Model (s): WCA CS NFC LCI

For the renewal of the certificate, we hereby inform you that some changes have been made to the above mentioned product(s). Please refer to the details on the next pages.

Change description

The change of tuning done on main PCB:

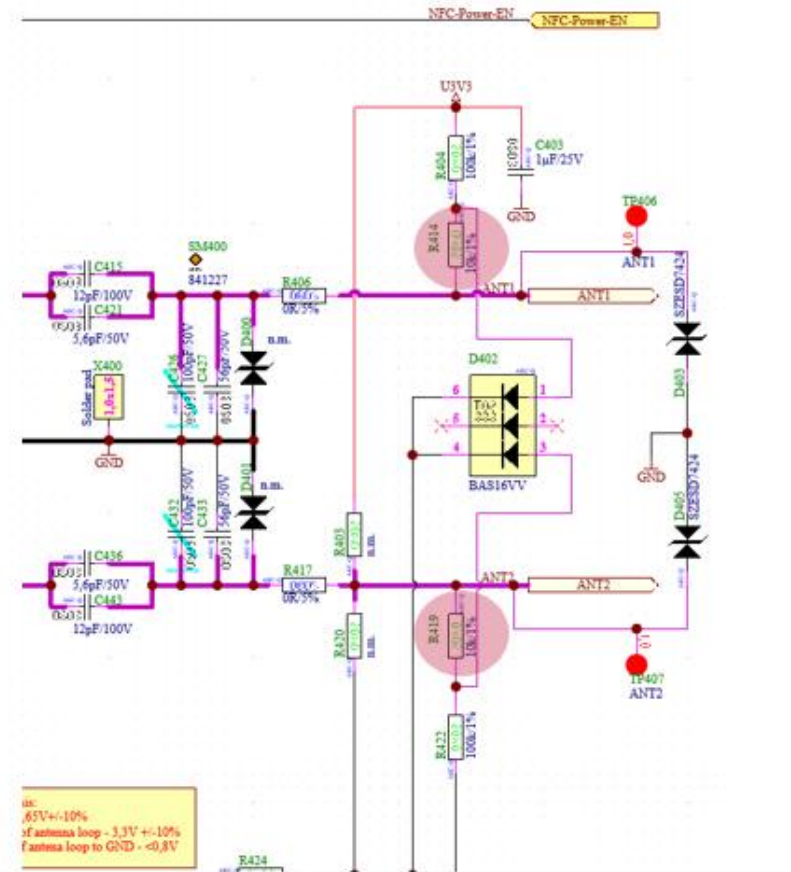
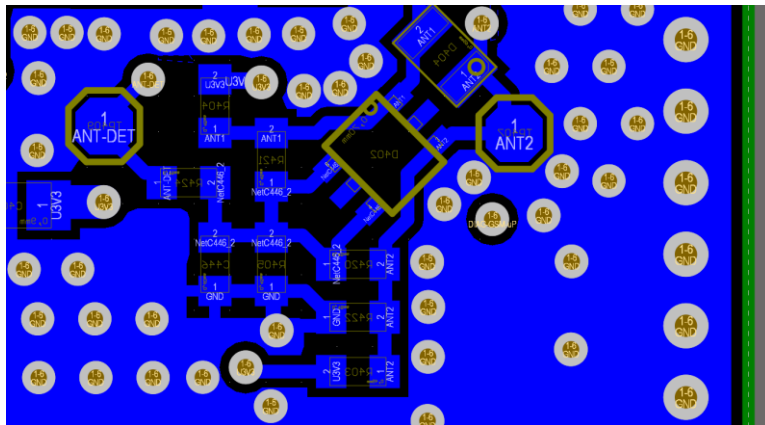
1.2. Change in main board - added 2 resistor, changed layout in region of Diode D402
